Rezoning Transportation Analysis

Petition Number: 2018-121

Date	Description
10-17-18	First Review
11-16-18	Second Review
1-23-19	Third Review
2-12-19	Fourth Review
2-18-19	Fifth Review

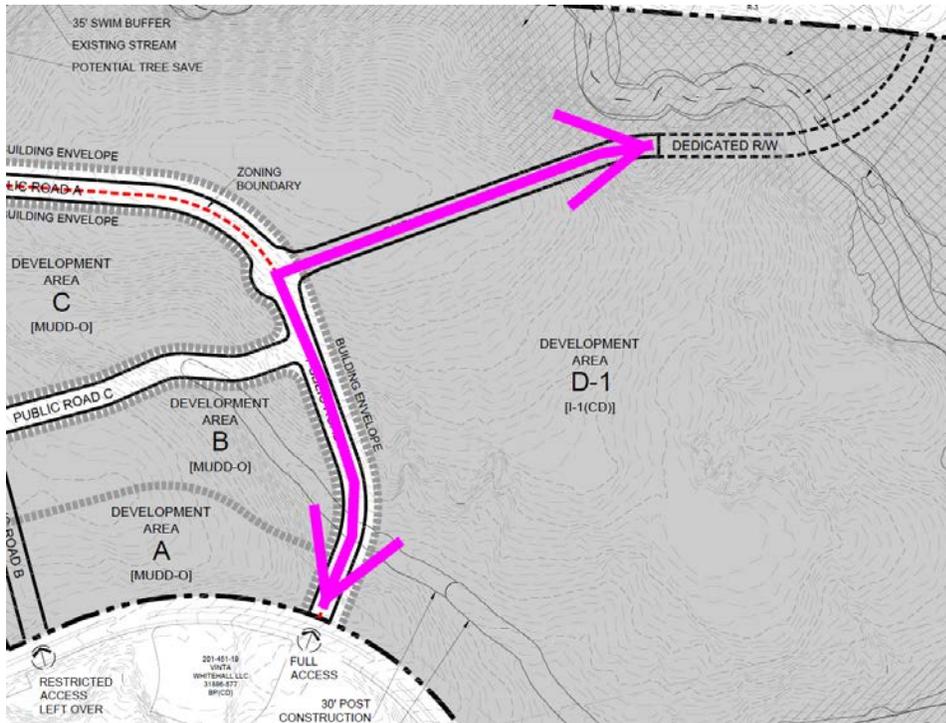
5. **The cross-sections for Public Road D and Public Road A (between West Arrowood Road and proposed roundabout) shown in the site plan do not support the future Shopton Road-Arrowood thoroughfare cross section. As stated in comment #4, the future right-of-way for the Shopton Road-Arrowood Road Connector is 86 feet to accommodate a cross-section of:**
 - a. 3-11’ travel lanes
 - b. 2-8’ buffer bike lanes
 - c. 2.5’ curb and gutter
 - d. 8’ planting strip
 - e. 6’ sidewalk.

This cross-section would meet the City of Charlotte ordinance, policy and design standards including the Council adopted Bike Plan and the Comprehensive Transportation Plan.

In addition, the three-lane section will provide space for left-turn lanes requirements into the future access points along the minor thoroughfare alignment. The need for the left-turn lanes is based on the future vehicular volume on this segment of road.
